HISTORIC PRESERVATION COMMISSION

SUBJECT: Historic Area Work Permit #469040 – second floor addition and window replacement

MONTGOMERY COUNTY HISTORIC PRESERVATION COMMISSION
STAFF REPORT

Address: 4 East Irving Street, Chevy Chase **Meeting Date:** 11/14/2007
Resource: Contributing Resource **Report Date:** 11/07/2007
 Chevy Chase Village Historic District
Applicant: Bob Kyle and Kate Fulton (Chris Snowber, Architect) **Public Notice:** 10/31/2007
Review: HAWP **Tax Credit:** Partial
Case Number: 35/13-07KK **Staff:** Anne Fothergill
PROPOSAL: Second story addition and alterations to house

Proposed Elevation - West

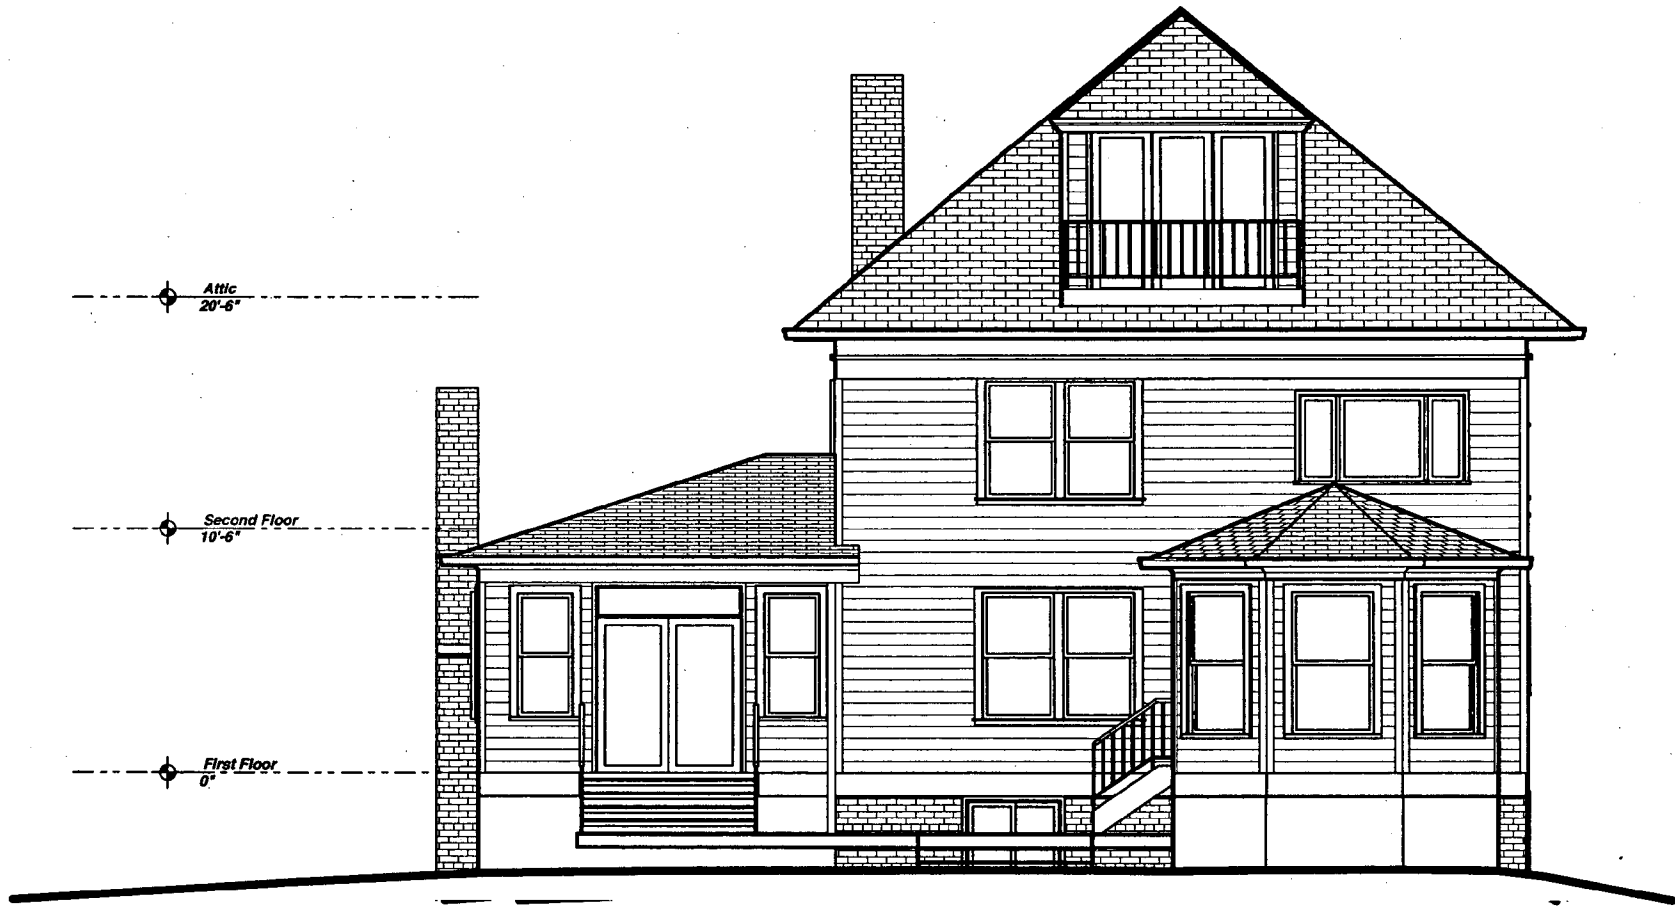
And so overall staff supports this proposal. The, I think it's thoughtful in an attempt to minimize impact to the historic house and the streetscape. The only thing that staff recommended was possibly to inset the rear elevation of the addition, so that the rear left corner of the house can still read, and there isn't one long plane across the back.

The side elevation here with the new chimney, the existing chimney extended upwards, new windows on the side here as well. Where we have narrower windows, we'd use a two over one light pattern, rather than a three over one. And around to the rear, the same thing, pairing of windows, and again, building right on top of the existing. So again, the same claim above and below. And that is more or less in the same plane as the corner of the house.
